VALENCIA SOUTH JSP 13-75 WITH REZONING 18.706 (PRO AMENDMENT)

Public hearing at the request of MI Homes of Michigan for Planning Commission’s recommendation to City Council for an amendment to Planned Rezoning Overlay Concept Plan associated with a Zoning Map amendment. The subject property was rezoned from R-1, One-Family Residential to R-3, One-Family Residential with a Planned Rezoning Overlay (PRO). The subject property totals approximately 41.31 acres and is located in Section 29, south of Ten Mile Road and west of Beck Road. The approved plan proposed a 64 unit single-family residential development. The current amendment is requested to allow for construction of a ranch floorplan within the Community.

PLANNING REVIEW

Revised PRO Concept Plan and Agreement: 1st Amendment to approved PRO plan

FLOOR PLAN: BLOOMFIELD - "R"
2,001 TOTAL SQ FT SCALE: 1/4" = 1'-0"

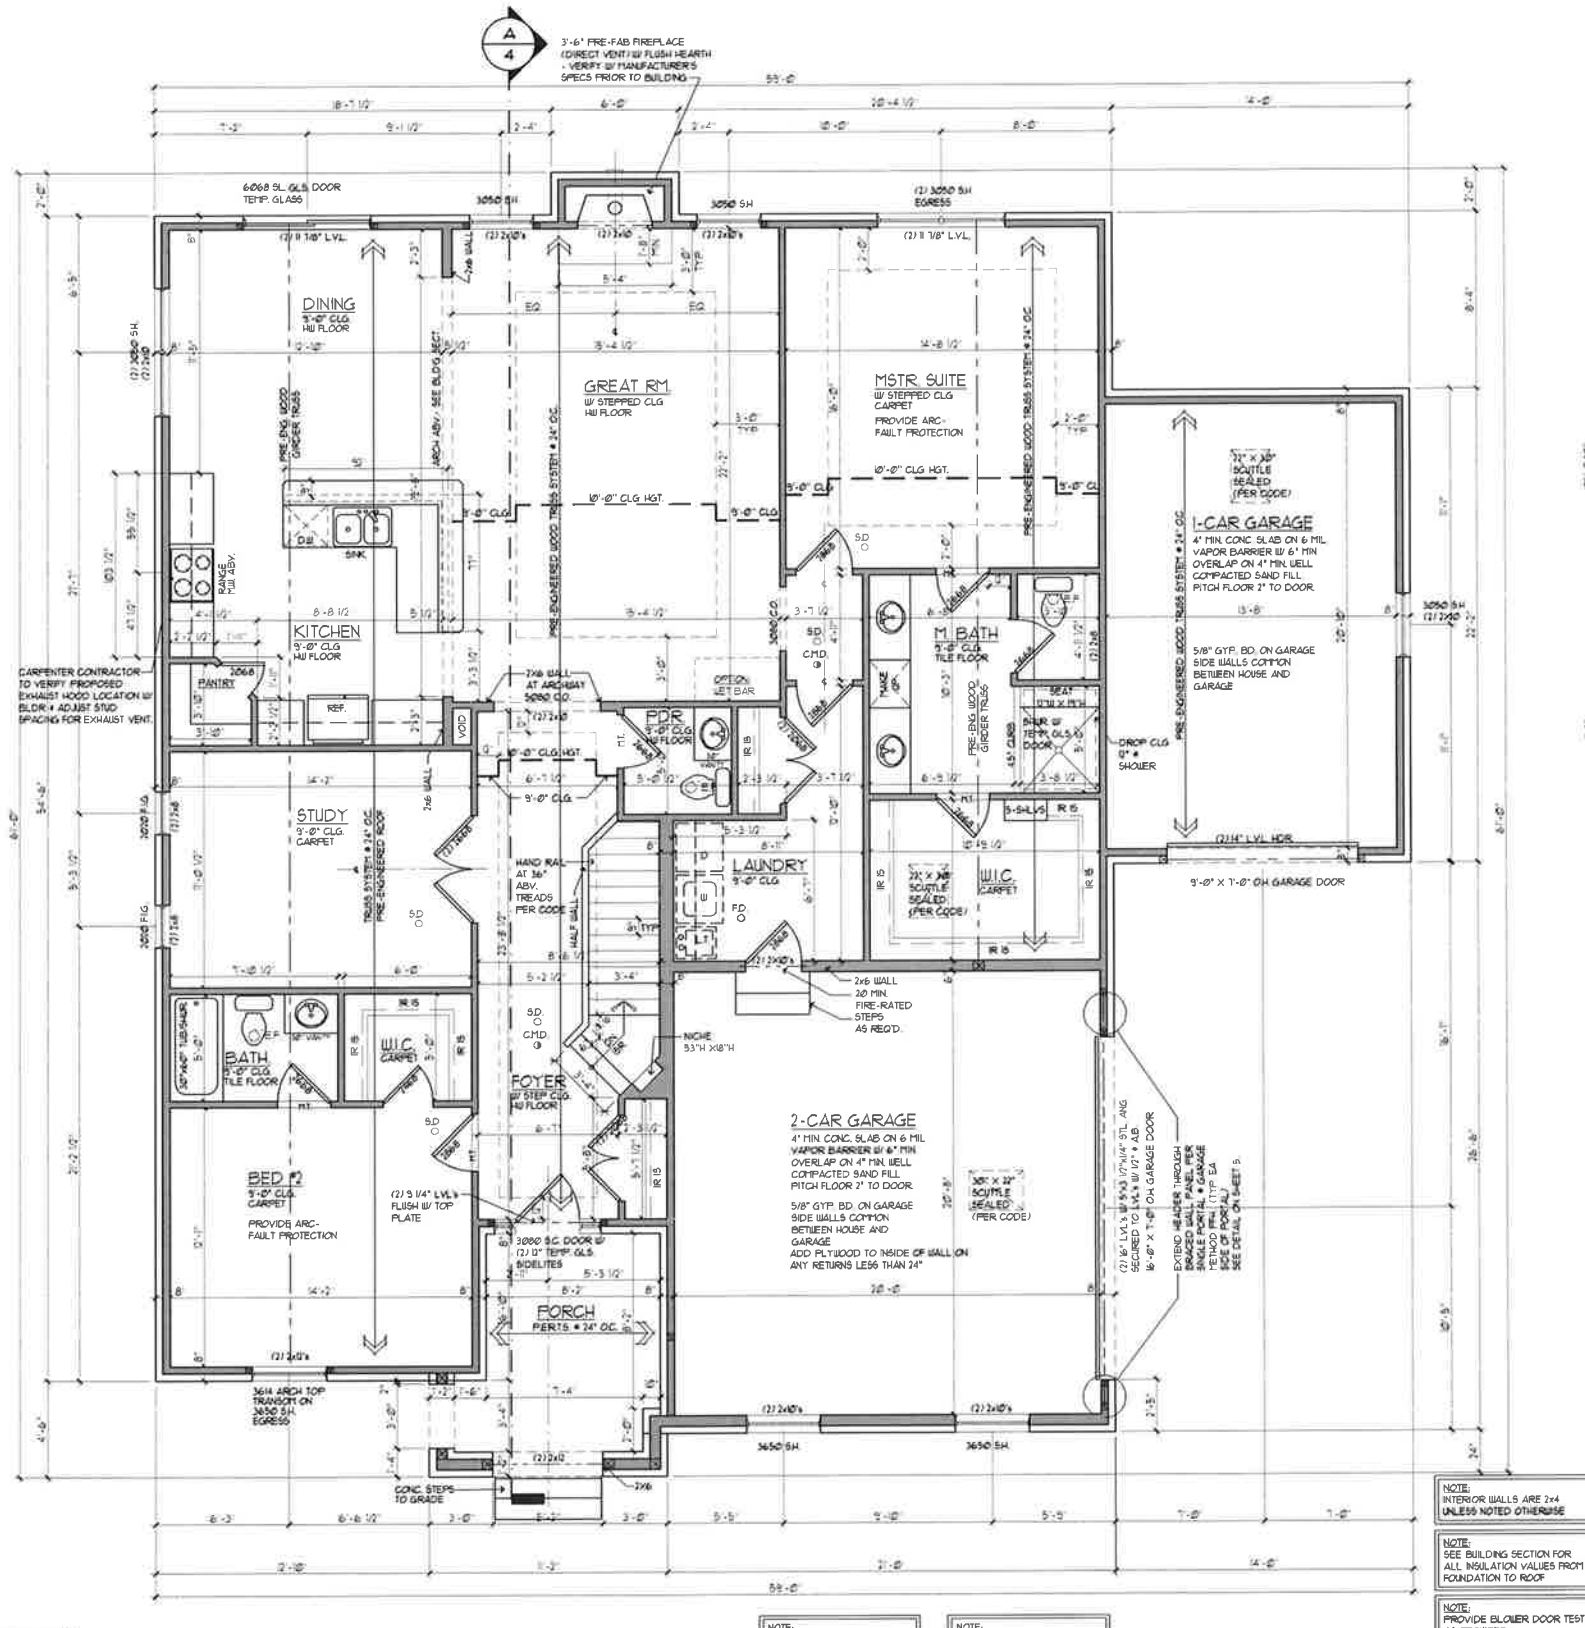
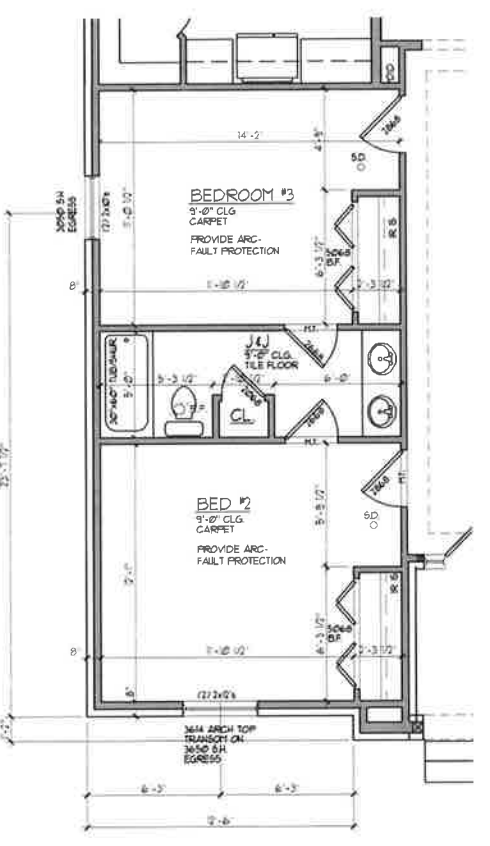
- Existing vs Proposed:** The applicant indicated in his cover letter that the average square footage of the existing, surrounding homes is 2,614 square feet and the proposed ranch plan is 2,001 square feet. However, staff does not agree with this finding. The average size of the approved models within Valencia South is 3,400 SF. The average size of occupied models is 3,600 SF. The average size of all homes within the surrounding neighborhood (within 350') is approximately 3,400 SF.

Recommendation – The applicant should submit other ranch style models that comply with the Ordinance with respect to minimum square footage (approximately 2,550 SF). Alternately, the applicant should provide data evidencing the differential in market value of a ranch style home as compared to an equivalent 2-story home. Unless a significantly higher value on a dollar per square foot basis can be demonstrated, we believe that the introduction of any model below the minimum size required by the Similar Dissimilar Ordinance would be inconsistent with the intent and purpose said Ordinance as well as the PRO, and moreover would set an undesirable precedent for future application of these Ordinances.
